**Marvel-Schebler® Aircraft
Carburetors, LLC**

Service Bulletin: SB-17

SUBJECT – BODY TO BOWL FUEL LEAKS

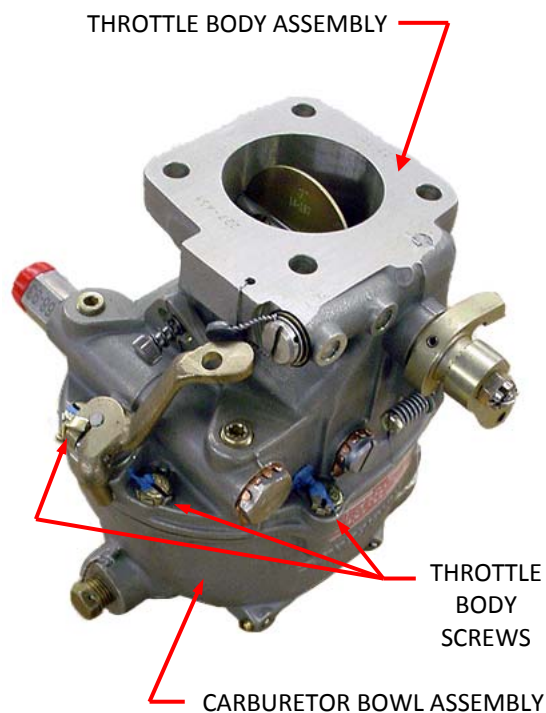
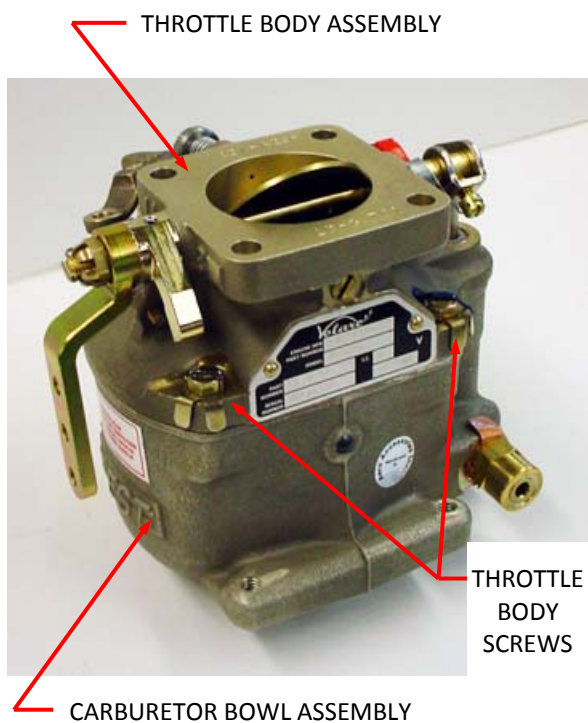
- Models MA-3™, MA-3A™, MA-3PA™, MA-3SPA™, MA-4™, and MA-4SPA™ have four (4) screws.
- Models MA-4-5™, MA-5™, MA-4-5AA™, MA-6™, and MA-6AA™ have six (6) screws.

c) Check each throttle body to bowl screw and lock-tab washer for any sign of looseness by attempting to wiggle the screw head and lock tab washer with your fingers.

Warning: Do not turn the screws with a tool (a screwdriver or wrench) when checking them it for looseness. Doing so with the lock-tab washers engaged against the screw may bend the lock tabs and compromise the lock-tab washers' effectiveness.

d) If there is evidence of fuel stains, looseness of the bowl relative to the throttle body, or loose throttle body to bowl screws, an appropriately rated mechanic, engineer, or repair station must: Remove the carburetor from the engine. In accordance with the appropriate carburetor service manual; remove the bowl from the throttle body. Inspect the threaded holes in the bowl and screws to be sure the threads are serviceable. Install a new body to bowl gasket. Install new lock tab washers. Install and torque the screws in accordance with appropriate specifications. Test the carburetor in accordance with instructions in the appropriate service manual. Secure the lock tab washers by bending the tabs.
